From: Official Information
Sent: Friday, 9 March 2018 4:54 p.m.
To: '██████████@fairfaxmedia.co.nz'
Subject: LGOIMA 18/029 response - wellheads material

Christchurch City Council (CCC) commissioned CH2M Beca Ltd (CH2M Beca) to carry out a review of 25 water supply wells at 9 primary water supply pump stations against *Bore Water Security Criterion 2 (bore head must provide satisfactory protection)* of the Drinking Water Standards New Zealand 2005 (revised 2008) (DWSNZ). The scope of works included inspecting the bores and determining their compliance with Criterion 2, recommending upgrades to improve bore head protection and DWSNZ compliance, and summarising the findings with one report per water scheme. This report summarises the findings for the wells supplying Dunbars Pumping Station.

6. Assessment of Bore Water Security Criterion 2 – Bore head must provide satisfactory protection

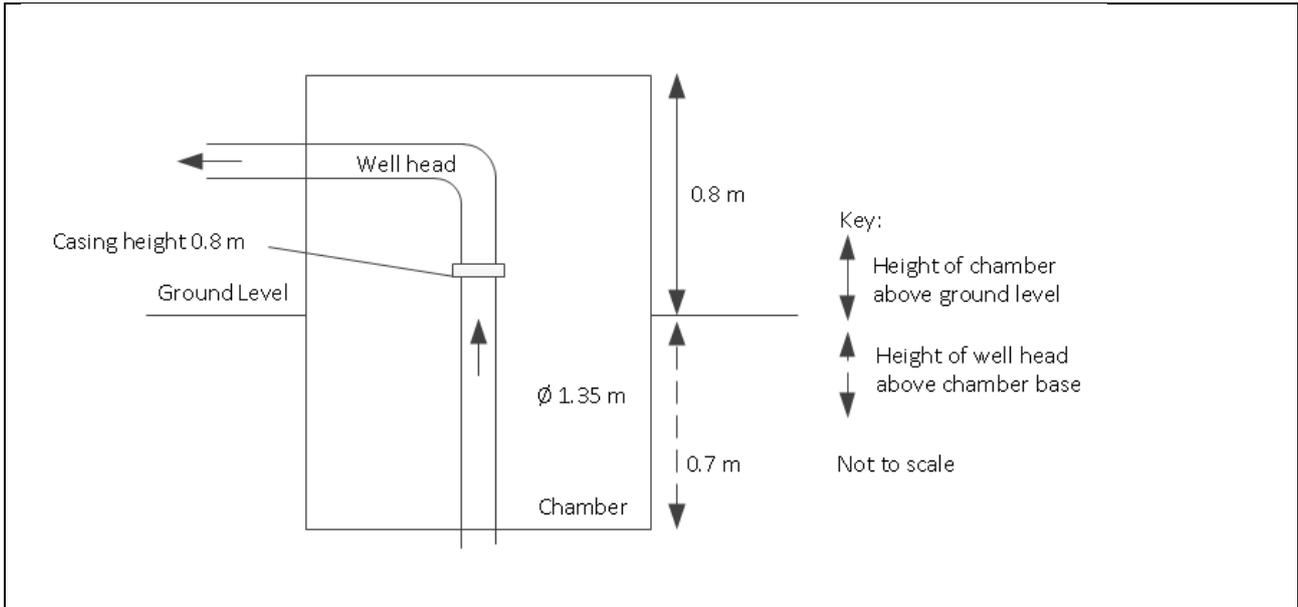
Chamber floor is gravel and so is not sealed from below. Casing is not sealed to chamber.

Signs of groundwater entering the chamber through the floor from outside.

Flow meter chamber near Dunbars Well 1 with water in the base and no sump pump

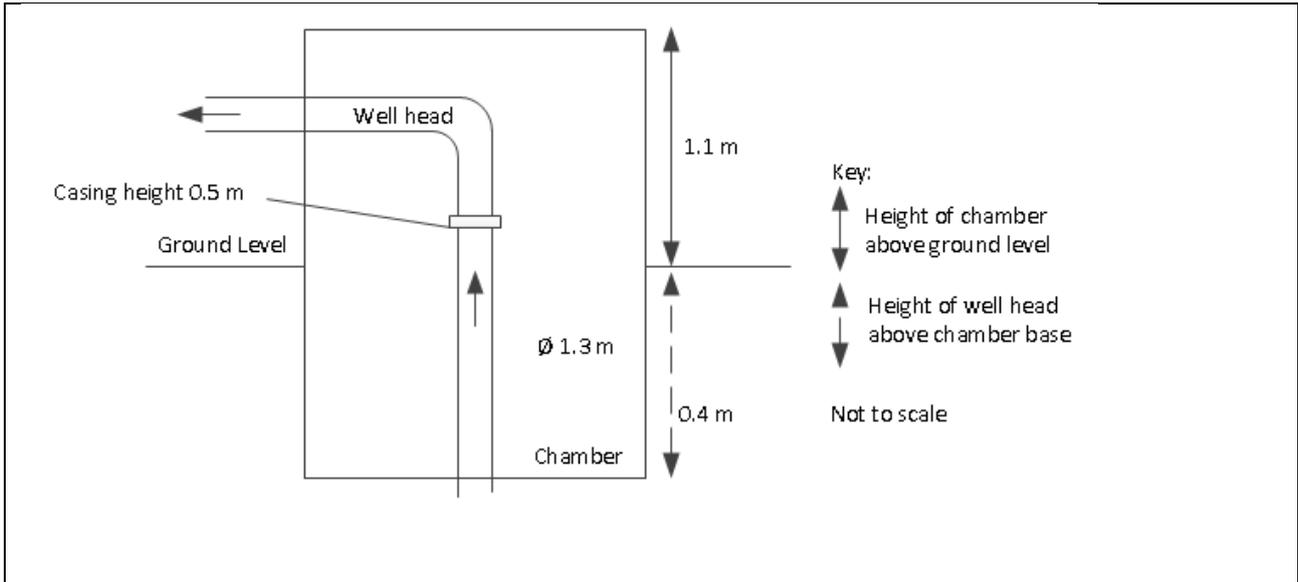
Type of Pump	Submersible
Frequency of Pump Use	Generally runs about once a day
4. Photo Record and Comments	
Photo	Comment
	Well chamber is 1.1m above ground. Located on the side of the road.
	Well is adjacent to sidewalk and road. A creek is on the other side of the well.

<p>Pipework in reasonable condition with some rust.</p> <p>Bottom of chamber is gravel.</p> <p>Sample tap not installed but connection point is present.</p>
	<p>Cables appear to be sealed</p>
	<p>A hole in the top of the chamber was seen. This is a possible source of water, or vermin, ingress</p>
<p>5. Diagram with Well Measurements</p>

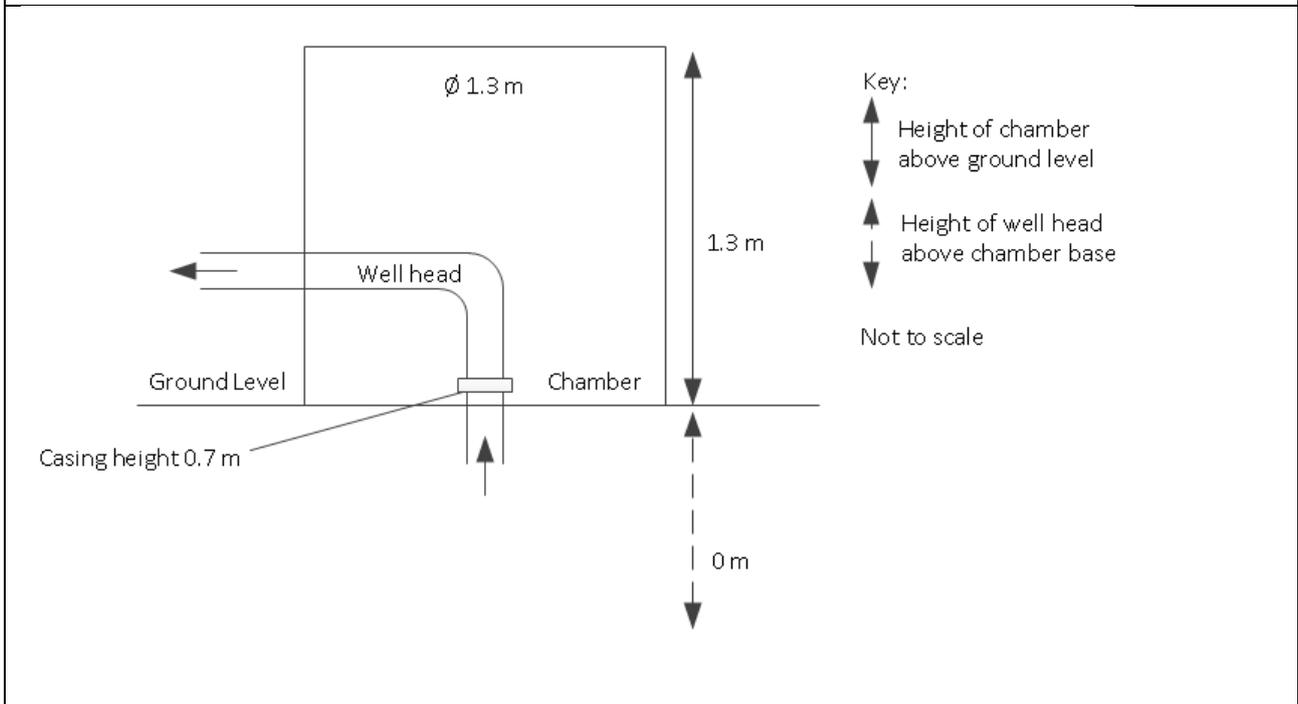
Type of Pump	Submersible
Frequency of Pump Use	Generally runs about once a day
4. Photo Record and Comments	
Photo	Comment
	Chamber sits on ground (not a below ground installation)
	<p>Pipework sealed with the chamber sidewalls. Sample connection point on top of pipework. A sample tap is brought to site for sampling.</p> <p>Gravel in bottom of chamber which allows water to come up through the ground and into the chamber.</p>

<p>Adjacent creek</p>
	<p>Adjacent road</p>

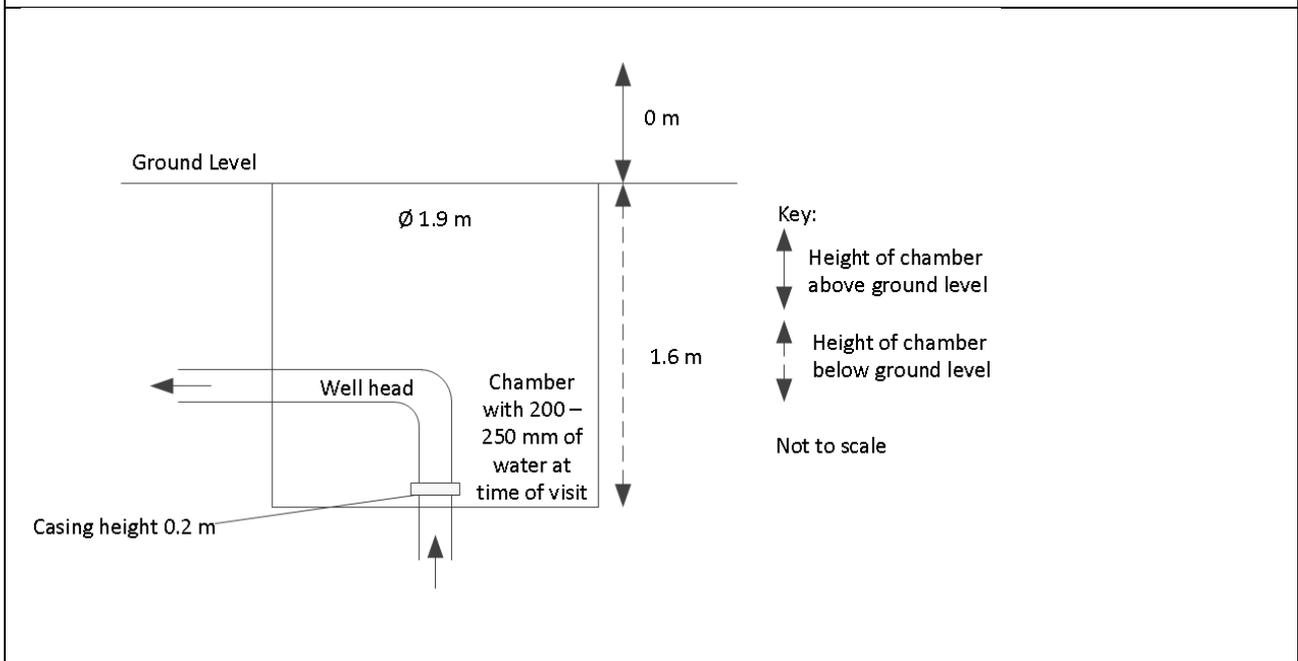
<p>Frequency of Pump Use</p>	<p>Generally runs about once a day</p>
<p>4. Photo Record and Comments</p>	
<p>Photo</p>	<p>Comment</p>
 <p>An aerial photograph showing a circular concrete well head located at the end of a paved driveway. The driveway is bordered by a white fence on the right and a road on the left. The well head has a central grate and is surrounded by a concrete curb.</p>	<p>Well is located at the end of a driveway, on the sidewalk and adjacent to a busy road.</p>
 <p>A photograph of a stormwater drain on a road. The drain is a rectangular grate set into the asphalt pavement. The road surface is wet, and there is some debris around the drain.</p>	<p>Stormwater drain on road approximately 2m away</p>
 <p>A photograph showing a drain from a driveway directed towards a well. Two workers in orange safety vests are standing near the well head. The drain is a small pipe that runs along the driveway and ends near the well head.</p>	<p>Drain from driveway directed towards well.</p>

<p>Water in bottom of chamber. Sump pump outside of sump. Ripples in water imply that there is a leak from the side of the casing near the cable duct.</p>
	<p>A photo of a new sump pump in the chamber that was received after the site visit (19 January 2018). The photo shows a small amount of water in the chamber.</p>

Does the bore head meet the requirements of Criteria 2	No, see actions below
7. Actions Arising	
Identify issues and rank them in terms of whether they require:	
First Priority	<ul style="list-style-type: none"> ■ Install a level sensor and a chamber level alarm ■ Seal the chamber lids ■ Seal cables, pipework and casing if not already sealed (could not assess due to water in chamber) ■ Replace lid and form an apron with a fall away from the lid ■ Install a downward facing air vent 0.5 m above 100 year flood level (unless the well is not located in a flood prone area)
Second Priority	<ul style="list-style-type: none"> ■ Modify sample tap so that it is either outside the chamber, or so that it contains a length of flexible hose that can be pulled outside the chamber when samples are collected ■ Consider decommissioning this well and replacing with an above ground well in a new location ■ Address the risks associated with the below ground bore in the WSP. This includes treatment and raising above ground where practicable. ■ We consider a single check valve at the headworks meets the backflow prevention requirements. This should be confirmed with the DWA. ■ Grout seals must be retrofitted. Requirements will be based on how soon the well will be replaced and the local contamination risks in the immediate vicinity of the well. ■ Ensure that the WSP addresses contaminant sources and contaminant migration pathways

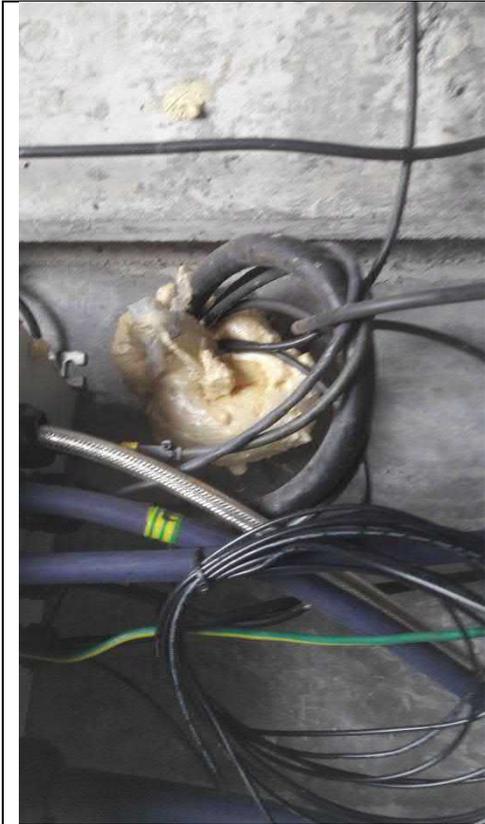
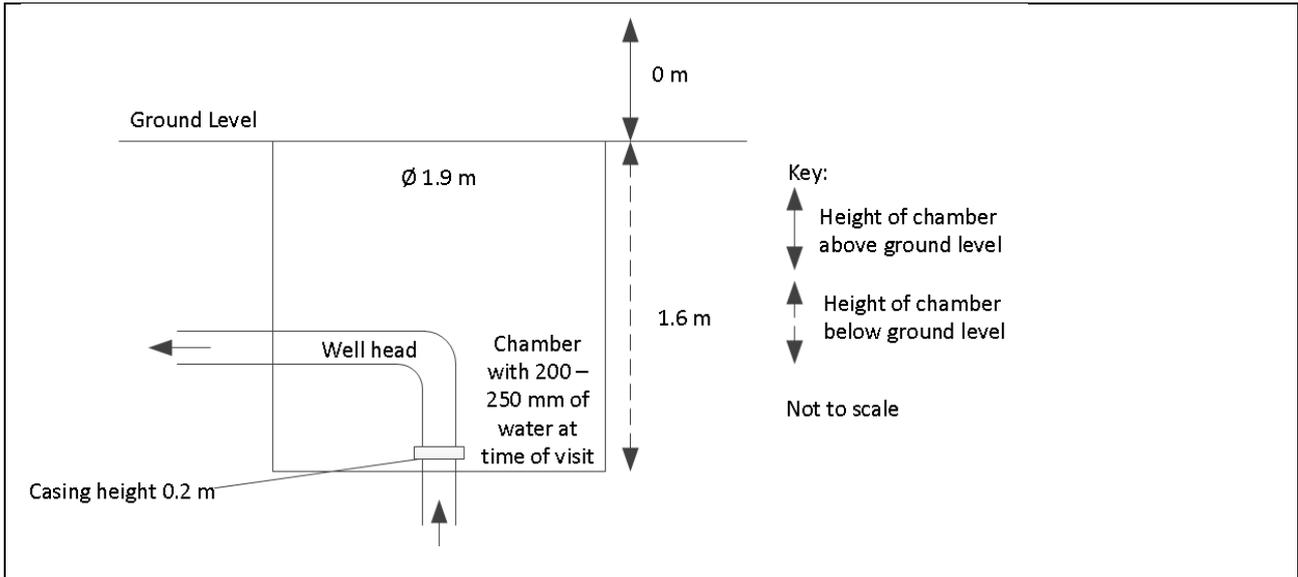
Chamber has a sump but no pump
Some pipe rust

Pitting and rust on casing

Untidy cable seals

Cable entry at side wall is not sealed

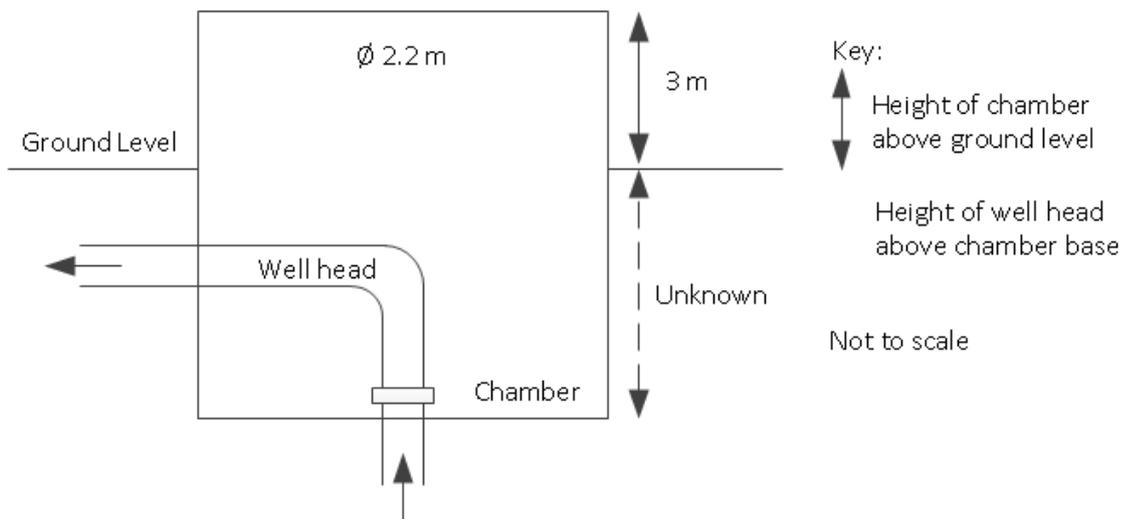
Date Drilled	12 September 1995
Control System/Alarms	Pump failure
Type of Pump	Submersible
Frequency of Pump Use	Approximately twice a week
4. Photo Record and Comments	
Photo	Comment
	Brookland Well 2 could not be accessed due to safety concerns. The chamber has recently been increase to ~3m above ground level and there is no railing or a permanent ladder
	Signs of leaking from inside the chamber

Evidence of ponding in the area

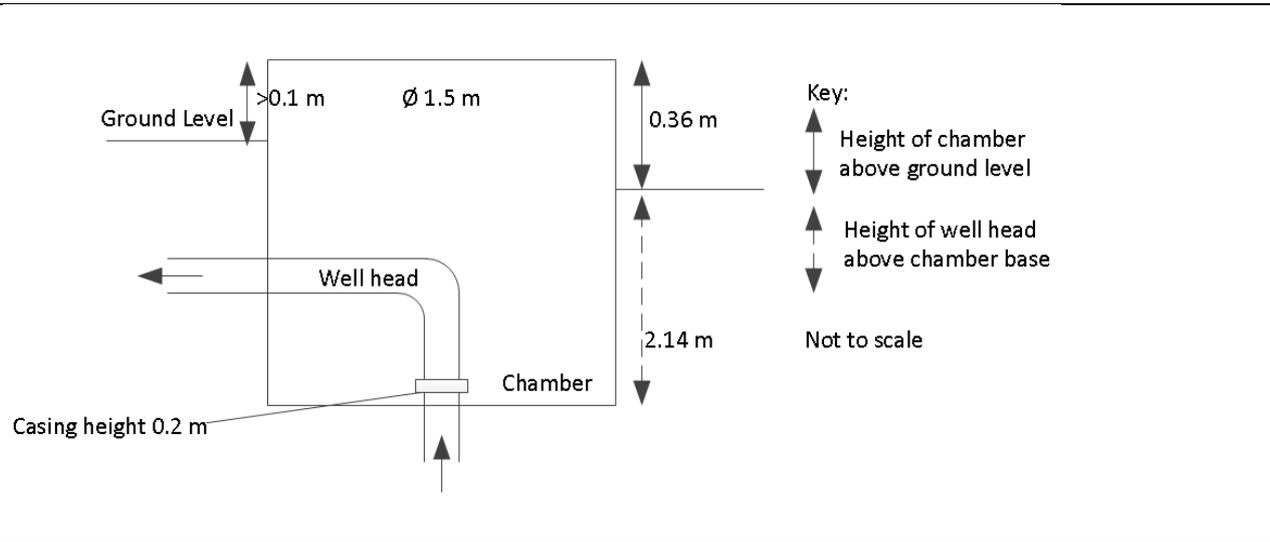
Some corrosion on the inside of the chamber. The source is unknown

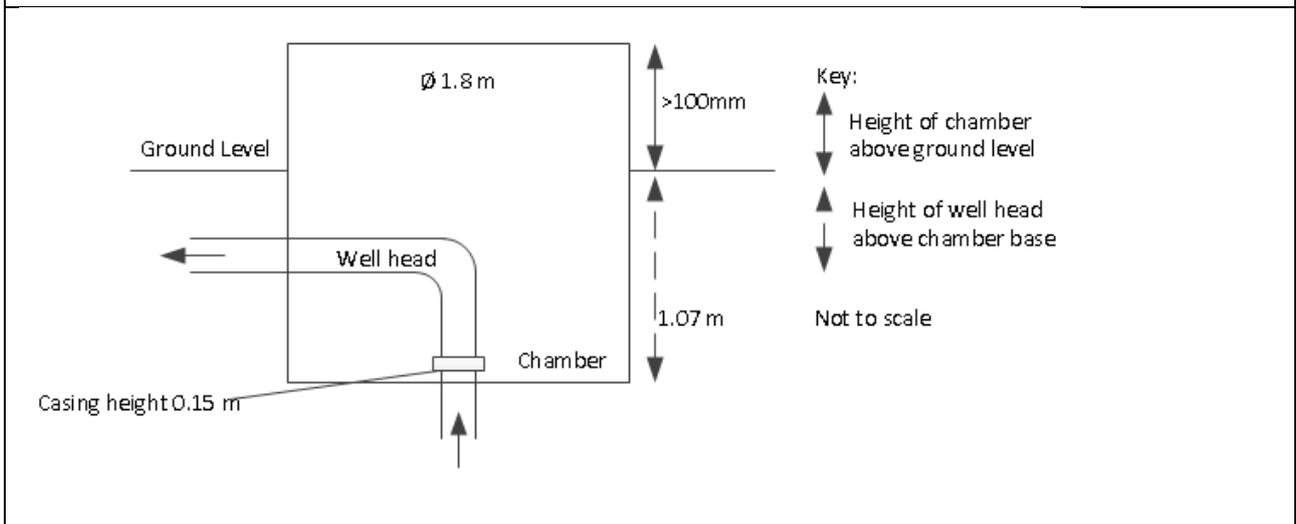
<p>Sealing on side entry to chamber has deteriorated</p>
	<p>Casing appears to be sealed to floor from photos</p>

First Priority	Second Priority	Third Priority	Ongoing
	<ul style="list-style-type: none"> Check cable entry points and seal if required 			
Well 2	<ul style="list-style-type: none"> Seal side entry to chamber Replace chamber lid so the chamber is protected from rainfall and runoff 			
Well 3	<ul style="list-style-type: none"> Install and seal cable glands Check that pipe wall penetrations are sealed Investigate bellows collapse and mitigate Investigate source of graffiti and trash. Mitigate likelihood of vandal access Seal chamber floor to prevent inundation from below. Ensure that casing is sealed to floor. Install a fence 5m away from well to minimise the likelihood of vandalism 	<ul style="list-style-type: none"> Modify sample tap so that it is either outside the chamber, or so that it contains a length of flexible hose that can be pulled outside the chamber when samples are collected

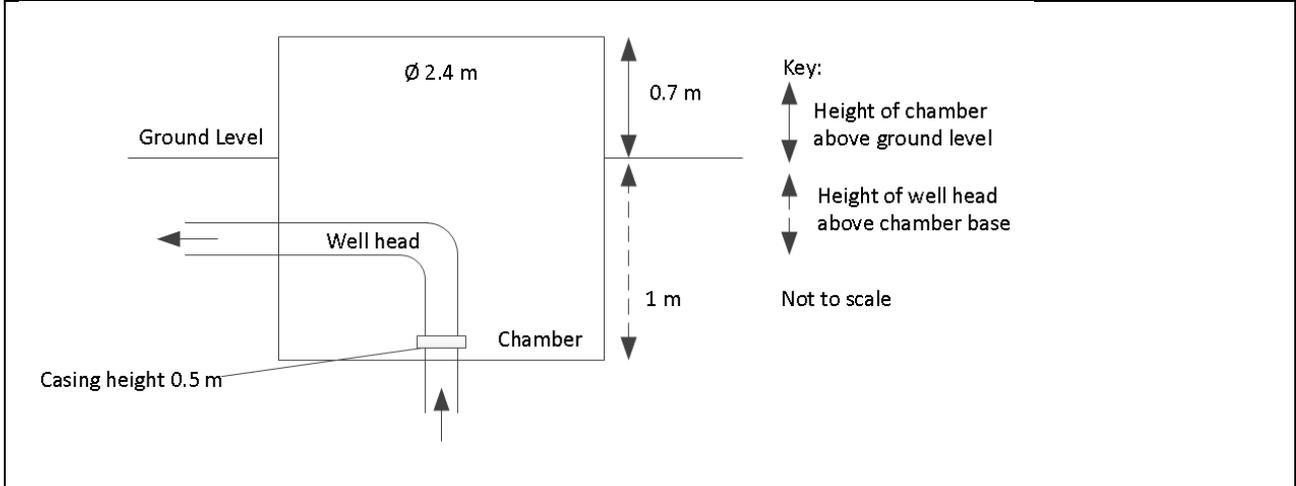
Type of Pump	Submersible
Frequency of Pump Use	Generally runs about once a day
4. Photo Record and Comments	
Photo	Comment
	Well is located in a small park, adjacent to a car park, surrounded by trash
	Sample tap is located in chamber

Rebar showing through the chamber wall

<p>Cable penetrations through wall are sealed</p>
	<p>Photo received 19 January 2018 following a clean-up of the well. The well chamber now appears clear of rubbish and debris, and the cable entry points into the well head appear to be sealed now.</p>

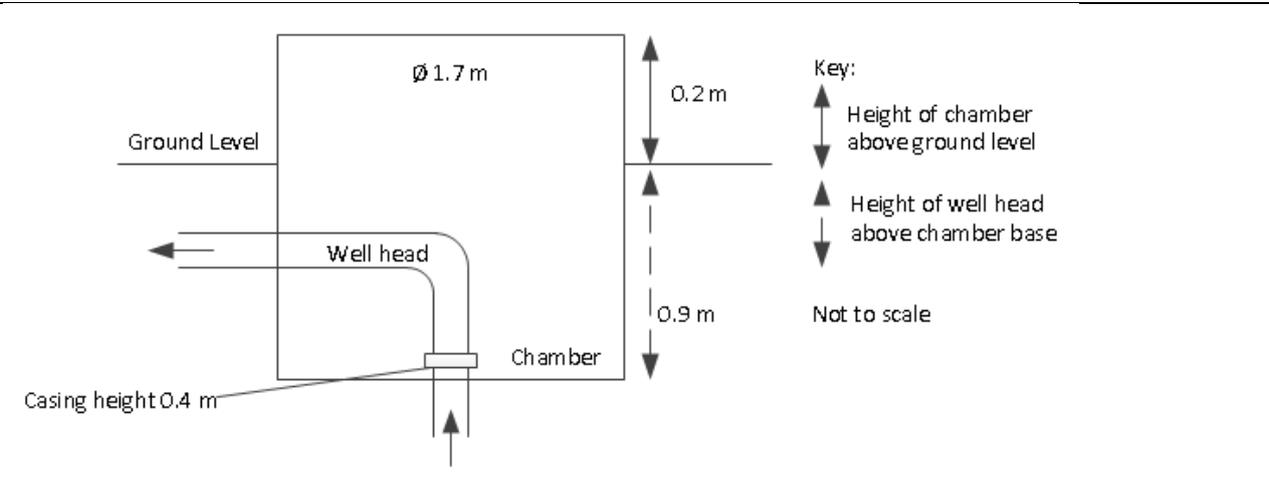
Type of Pump	Submersible
Frequency of Pump Use	Generally runs about once a day
4. Photo Record and Comments	
Photo	Comment
	Well chamber within a partially fenced area, part of a residential community. Signs on ponding on footpath adjacent to well
	Pipework in reasonable condition
	Pipe penetrations through wall are not sealed
	Casing sealed to chamber floor

Cable glands sealed

Sump without a sump pump installed

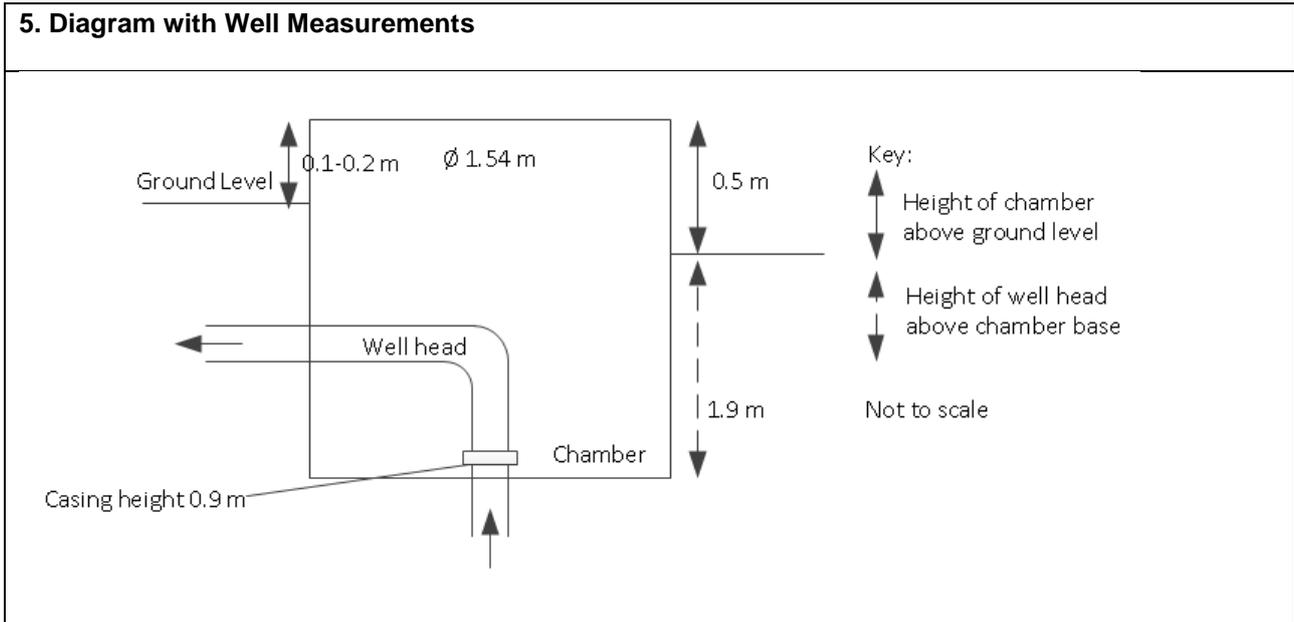
Sample tap drains into chamber. Some chamber corrosion behind sample tap.
	Pipe penetration through chamber wall not sealed. Dirt floor, not sealed
	Cable penetration through chamber wall not sealed

a) Water Ingress:		
Condition of seals (see NZS:4411 2.5.5.3 & 2.5.5.4)	Cabling	Glands not sealed
	Pipework	Not sealed
	Well casing	Could not be viewed in person or with a camera
Any history of E. coli transgressions? Historical and current levels of total coliforms?	20 distribution system E. coli transgressions have been recorded in the data received (dating back to 2012-13 FY). The source is unknown and may not be this well. Total coliform levels are unknown	
Sanitary well seal watertight or elevated 0.5m above 100 year flood level	No Some of the site is below the 50 year flood level and so there is the potential for flooding	
Downward facing air vent 0.5m above 100 year flood level	Not installed	
Type and condition of borehead pipework (above ground)	Good	
Raw Water sample port?	Yes, in chamber	
Concrete apron sloped to drain away from well?	No	
100mm step above ground level?	N/A
